SUBMITTAL IDENTIFICATION SHEET

WEBSTER UNIVERSITY ISB
PROJECT NAME

075323-004
CONTRACTOR / CM SUBMITTAL NO.

075323
SPECIFICATION SECTION / PARAGRAPH

#2nd OPTION
DYNA-GUARD
800-821-5448

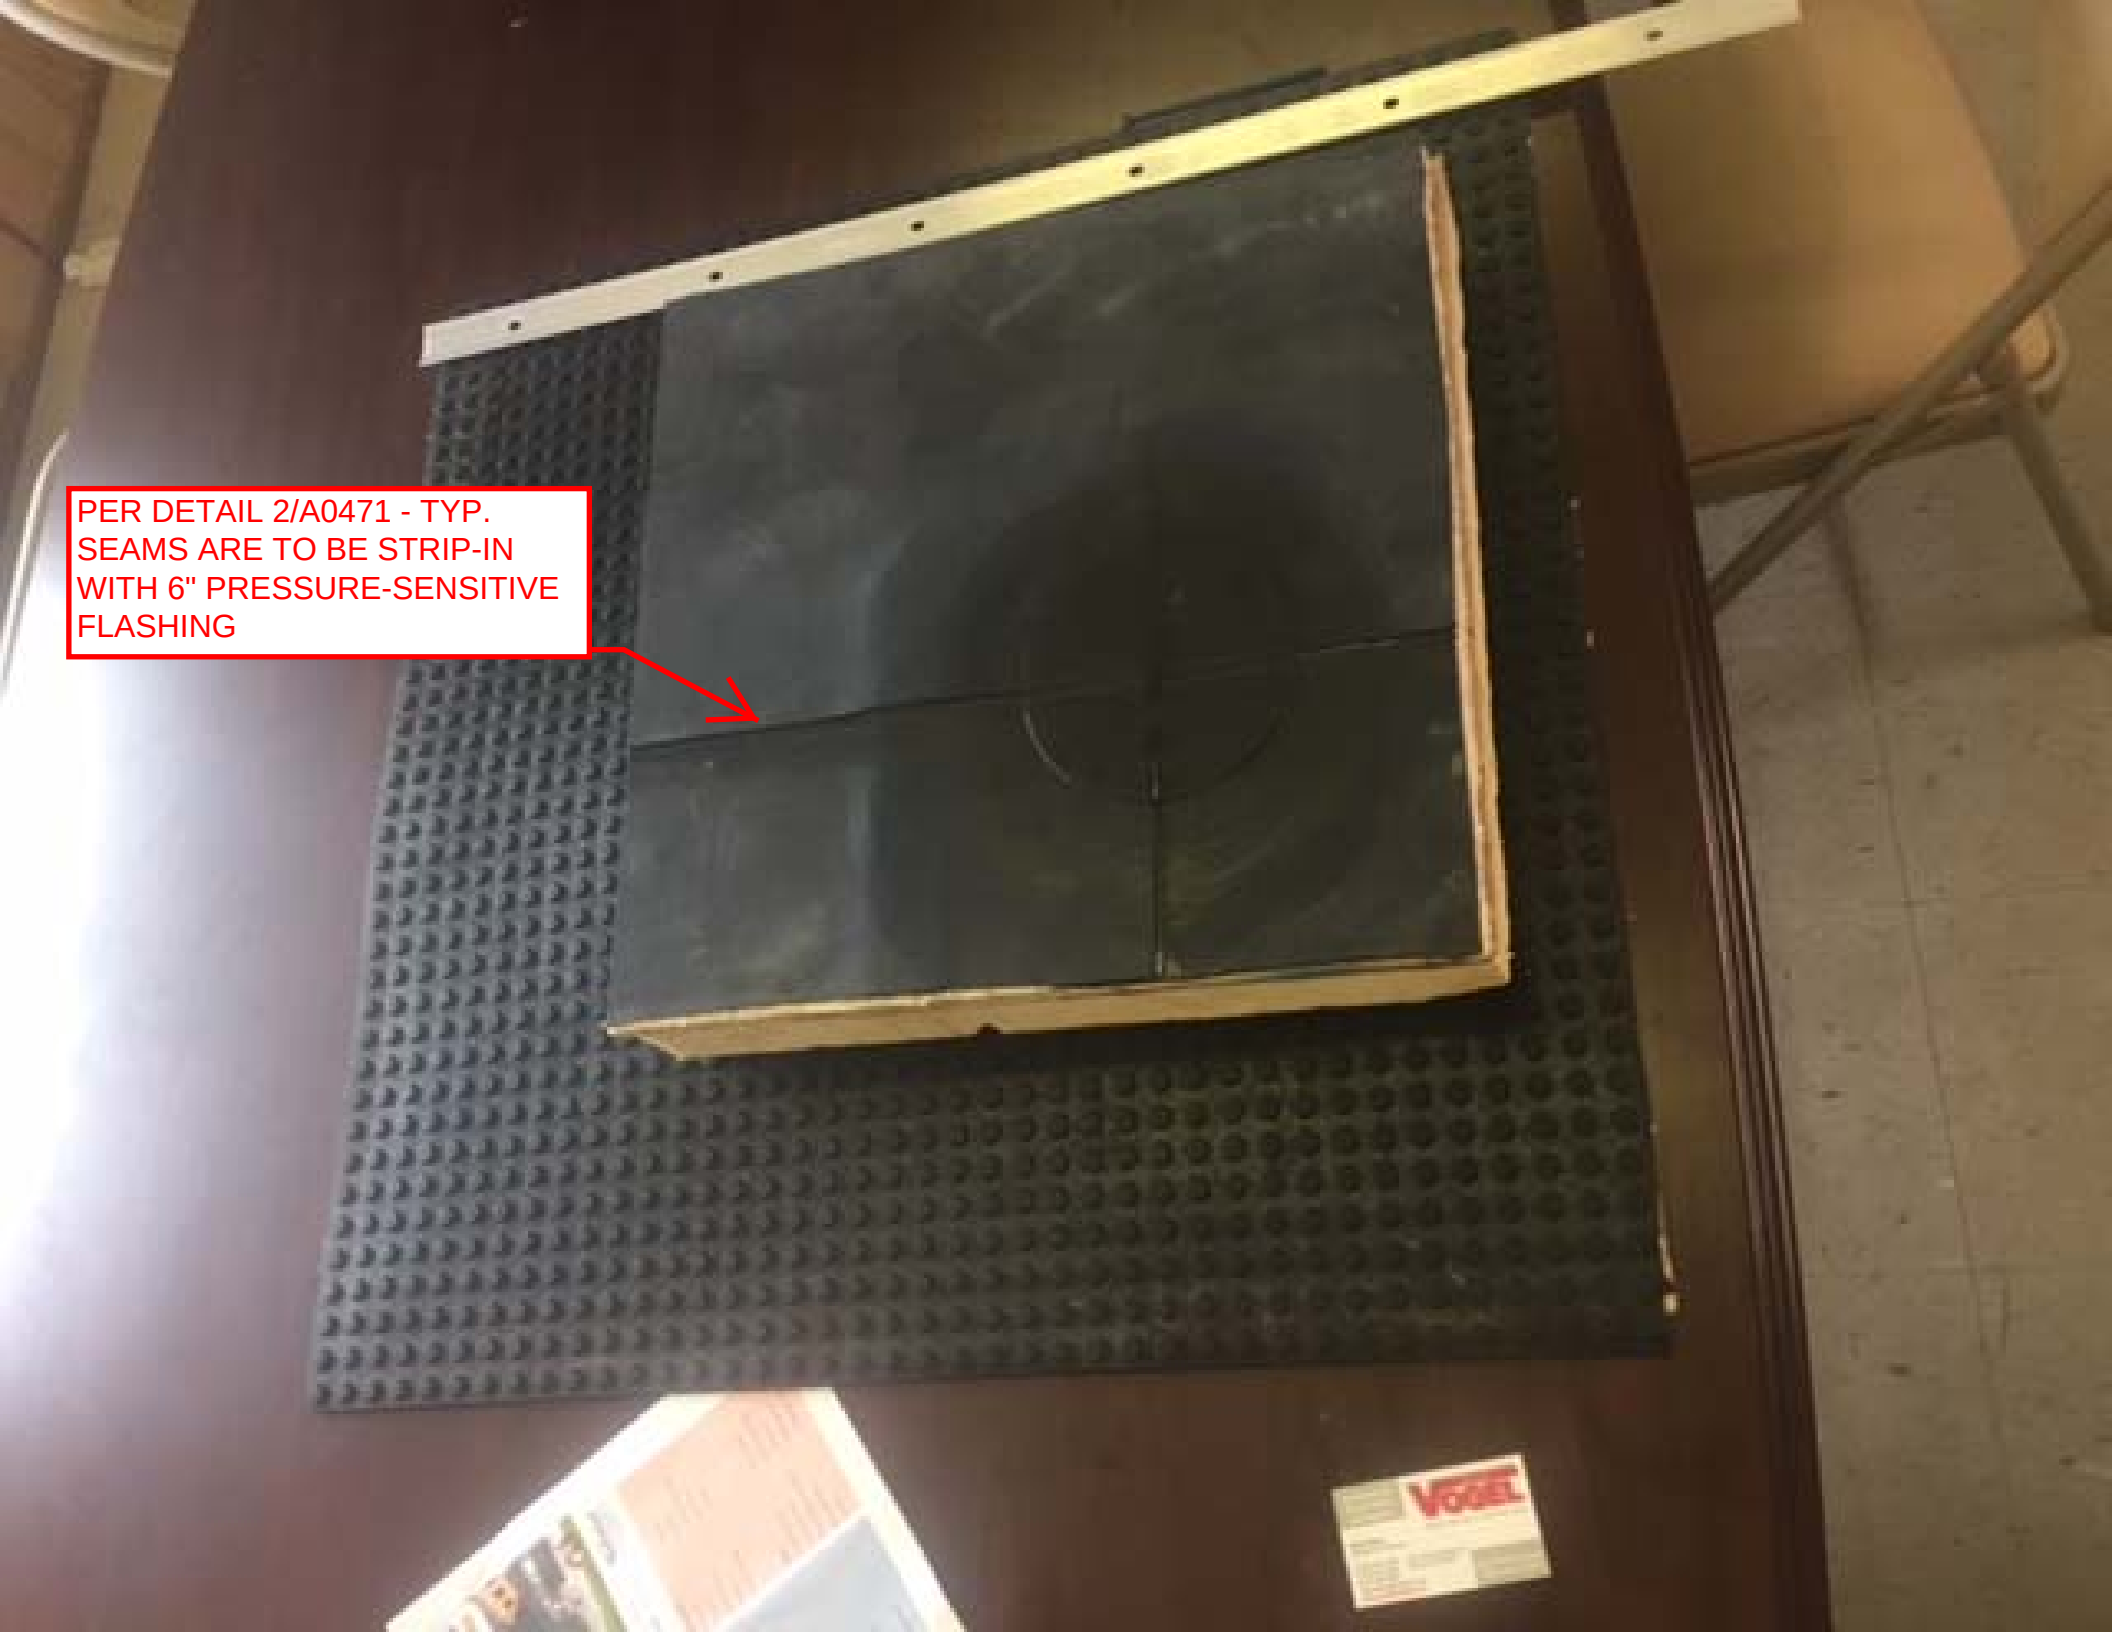
PER DETAIL 2/A0471 - TYP.
SEAMS ARE TO BE STRIP-IN
WITH 6" PRESSURE-SENSITIVE
FLASHING
VOGEL

All samples submitted are approved unless noted otherwise. See below - #2 option for the fasteners are approved, #1 option for fasteners are rejected. Per detail 2/A0471 all EPDM seams are to have 6" pressure-sensitive flashing applied over seams.
